CARMEL DAM  
(WEST BRANCH RESERVOIR)

PUTNAM COUNTY, NEW YORK  
INVENTORY NO. 29

PHASE I INSPECTION REPORT  
NATIONAL DAM SAFETY PROGRAM

CROTON RIVER BASIN  
CARMEL MAIN AND AUXILIARY DAMS  
INVENTORY NO. 29  
PHASE I INSPECTION REPORT

LOCATIONS OF OBSERVATIONS  
WEST BRANCH RESERVOIR  
MAIN CARMEL DAM  
NOT TO SCALE

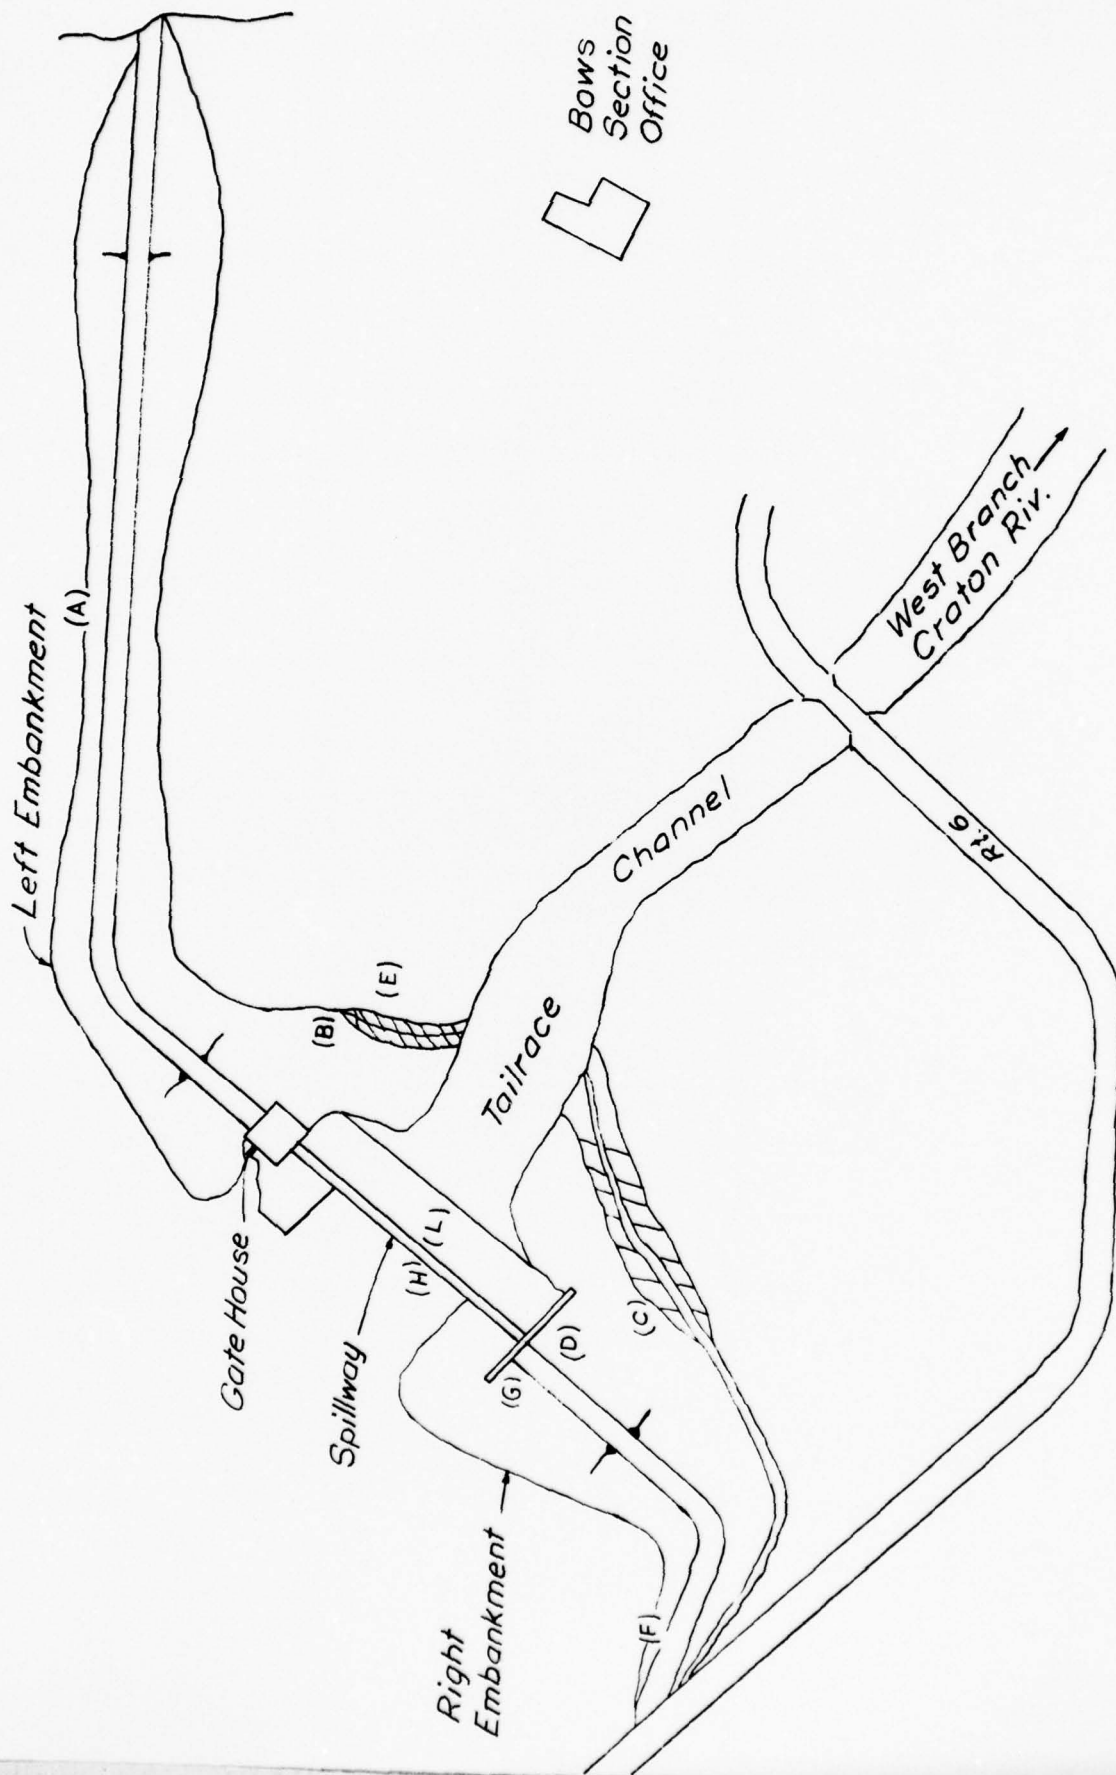
(A) Trees are growing near and at the upstream toe of the left embankment.

(B) Seepage emerges from the lower portion of the abutment contact of the left embankment. The water appears near the old paved collector ditch and flows in and near the ditch. The surface of the embankment and abutment in the area of seepage is wet and soggy. The embankment surface shows minor irregularities which are thought to be made by the maintenance tractor in the wet ground. Because of the soggy surface the vegetation was not cut in the area.

(C) Wet, soggy ground exists but no seepage water appears at the lower part of the abutment contact of the right embankment. Surface irregularities similar to those found at the left abutment were also noted here.

(D) Some bushes are growing on the downstream slope of the right embankment near the spillway wall.

(E) There are some animal burrows (approximately 8-in. in diameter) on the left abutment near the embankment contact.

(F) Minor damage has been noted in the stone slope protection at the far right end of the right embankment.

(G) The upstream stone slope protection has developed a depression and a bulge to the right of the spillway. In this area there is a crack in the slope protection which is associated with the slight downward movement of the stones.

(L) Although the inspection was made at a time when the reservoir level was below spillway crest, considerable amounts of water were cascading on the downstream face of the spillway. The water emerged from between the joints of stones facing the spillway at all levels but the heaviest flow came from the joints of the top 2 or 3 layers.

(M) The top two layers of surface stones have been dislocated from their original position and pushed (probably by ice) downstream. The alignment of these two rows of stones has a downstream curvature.

- a. The stonework, serving as spillway facing needs to be repaired in order to correct the seepage condition noted at locations (L) and (M).
- b. The seepage and wet conditions noted at locations (B) and (C) should be systematically observed and possibly corrected by trench drains or protected by filter blankets.

- e. The following measures can be carried out as part of the maintenance work: Removing trees and bushes, repairing minor damage and erosion of slope protection, clearing debris, and treating animal burrows. (Locations (A), (D), (E), (G), (I) and (K)).

- f. Some of the observations, such as the minor upstream slope protection damages at locations (F) and (J) do not require any action at present, however periodic observations are recommended to detect potential further deterioration in the future.

LOCATIONS OF OBSERVATIONS  
WEST BRANCH RESERVOIR  
AUXILIARY DAM  
NOT TO SCALE

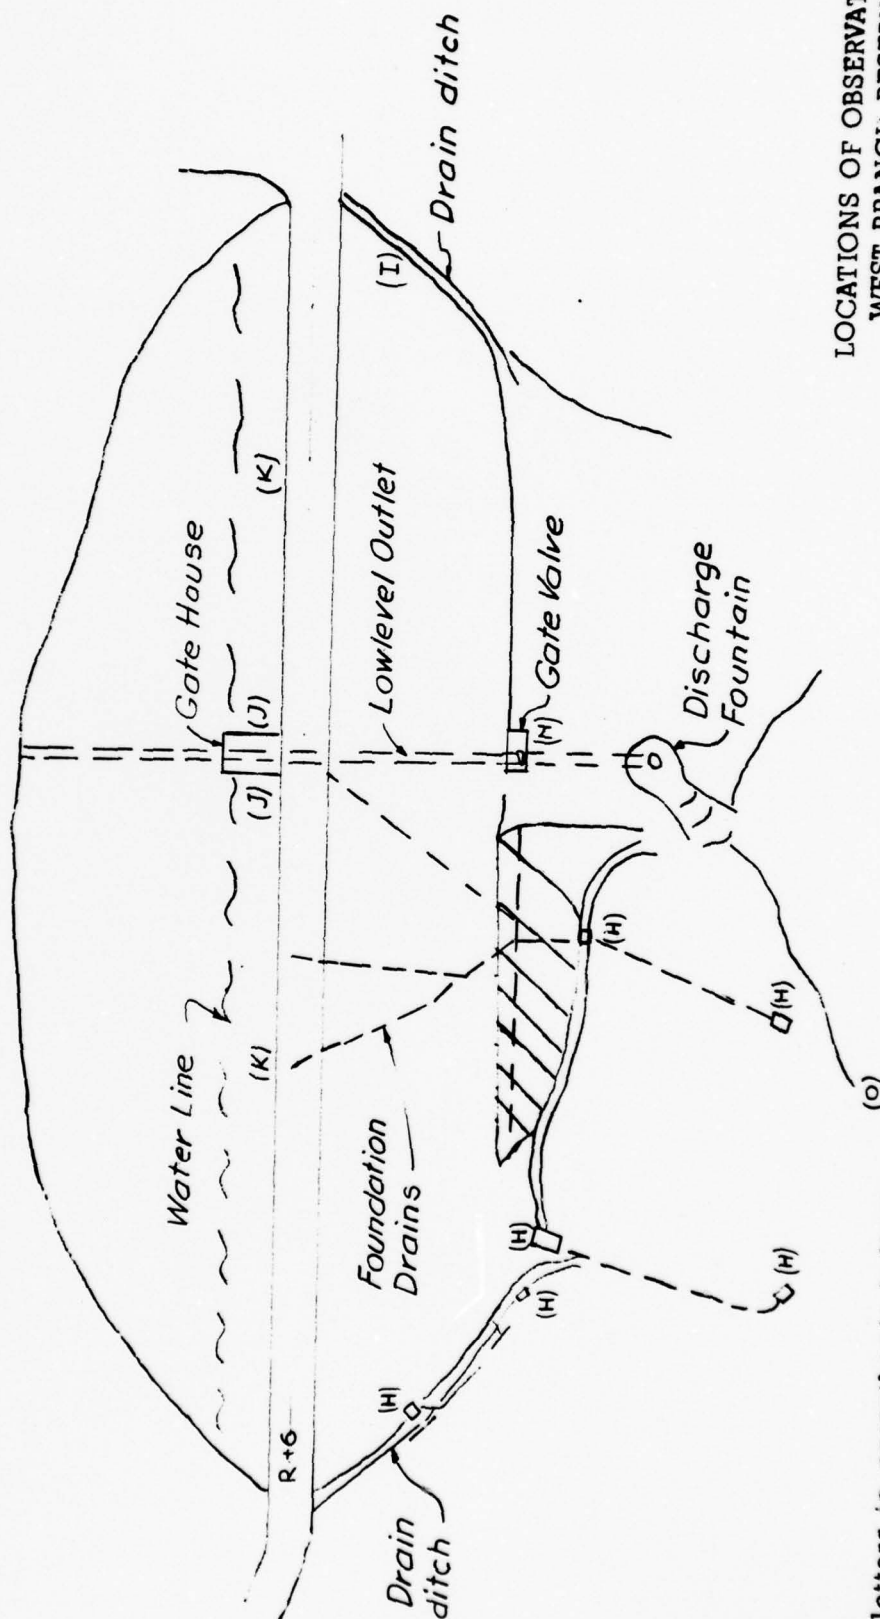
(H) The access vaults and manholes of the drain system are partially clogged with debris, sand and leaves. The seepage measuring weirs of the system are not operational.

(I) There is minor erosion made by surface runoff from the highway on the downstream slope near the left abutment contact.

(J) The stone protection on the upstream slope has developed some minor damage on both sides of the gate house.

(K) Some saplings and bushes are growing on the upstream slope.

(N) The 36-in. gate valve at the auxiliary dam is broken and stuck in a partially open position.

(O) The stream bed and its banks downstream of the auxiliary dam are cluttered with debris and are overgrown with vegetation.

- c. The drain system of the Auxiliary Dam should be cleaned and new seepage measuring devices installed (Location (H)).
- d. The 36-in. gate valve at Auxiliary Dam should be repaired (Location (N)).
